You will find enclosed a copy of Service Bulletin S07MU regarding the power steering reservoir cap on your 2008 model year Blue Bird "Vision" buses.

Power Steering Reservoir Cap

MODELS AFFECTED: 2008 BBCV Vision

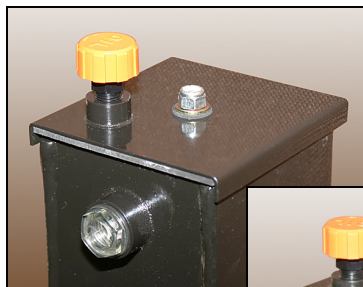
- 1** Park vehicle on a level surface, apply parking brake, turn engine off, remove ignition key and chock wheels.
- 2** Open engine hood and locate Power Steering Reservoir on driver's side frame rail.
- 3** If fluid leakage exist around reservoir cap, clean the area and adjacent components before proceeding.
- 4** Remove and retain Breather from Reservoir Cap.
- 5** Remove and discard retaining nut, flat washer, rubber washer and reservoir cap.
- 6** Check reservoir fluid level. Fluid level should be at the half way point of the site-glass.

Old Design

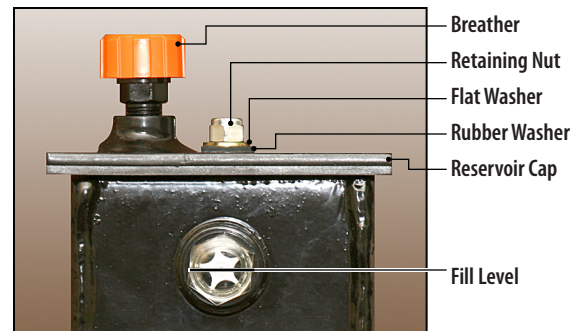
Power Steering Reservoir Cap allows fluid leak.

Replace the existing reservoir cap with the newly designed reservoir cap.

- 8** Install new Reservoir Cap w/gasket, rubber washer, flat washer and retaining nut supplied in kit (Blue Bird Part #0126305). Torque retaining nut to 10 ft. lbs.

CAUTION Do Not apply any type of gasket sealant.

- 9** Install original Breather in new Reservoir Cap.
- 10** Start engine and steer bus full left to full right 5 - 6 times.
- 11** Check Reservoir Cap and Breather to ensure leaks have been resolved.
- 12** Recheck fluid level in site-glass.
